Staff Report
City of Richmond, Virginia

Commission of Architectural Review

| COA-103051-2021 | Final Review | Meeting Date: 12/21/2021 |
| Project Description | Rebuild a previously removed covered front porch. | |

Figure 1. Current photo of front façade

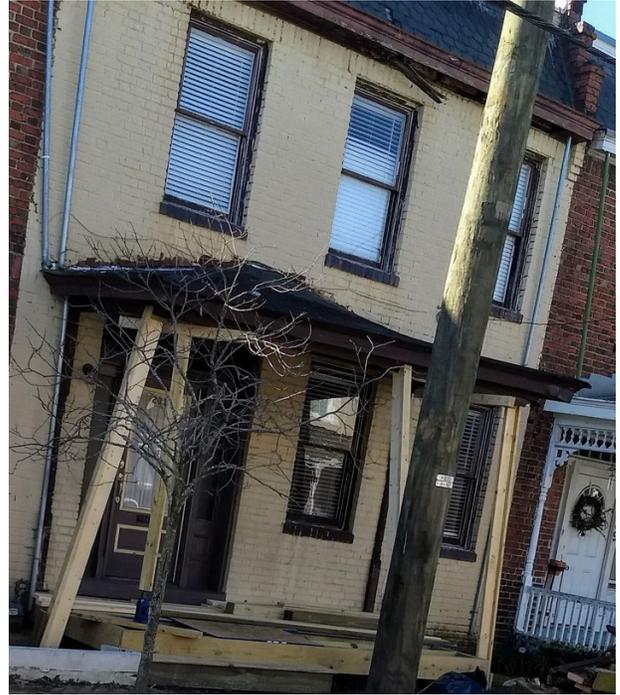
| Guideline Reference | Reference Text | Analysis |
|---|--|--|
| <p>Building Elements, porches, entrances, and doors #4 pg. 71</p> | <p><i>Do not remove or radically change entrances and porches important in defining the building's overall historic character. Front and side porches are architecturally more ornate than utilitarian back porches.</i></p> | <p>Based on photographic documentation of 2311 Venable Street, the original front porch featured decorative spindle work, sawn brackets, and turned posts. This design is also present on other unaltered front porches on the adjacent attached residences. Staff notes that the entirety of the front porch has been removed with the exception of the turned posts that are attached to the front façade.</p> |
| <p>Building Elements, porches, entrances, and doors #8 pg. 71</p> | <p><i>Do not strip entrances and porches of historic material and details that should be retained in any repair or partial replacement.</i></p> | <p>The applicant has removed the entirety of the original front porch, with the exception of the turned posts that are attached to the front façade. <u>Staff recommends that the applied turned posts on the front façade be retained.</u></p> |

| <p>Conditions for Approval</p> | <ul style="list-style-type: none"> • Staff recommends that the reconstructed front porch match the original design as closely as possible. The details to be retained have been ranked by priority below. If it is not feasible to make all of the repairs at this time, the lower priority elements may be added in the future as resources come available. Final drawings and material specifications should be submitted to staff for administrative review and approval. <ul style="list-style-type: none"> ○ High Priority: Repair and retain the existing turned posts that are attached to the front façade. ○ High Priority: Incorporate turned post columns matching the existing turned posts into the porch design. ○ Lower Priority: Incorporate architectural details matching the original front porch, including spindle work frieze and sawn brackets. If submitted at a later date, approval to be completed administratively. • Staff recommends the use of a Richmond Rail design for the new porch balustrade. • Staff recommends that the new TPO roofing be a dark color, submitted to staff for review and approval. |
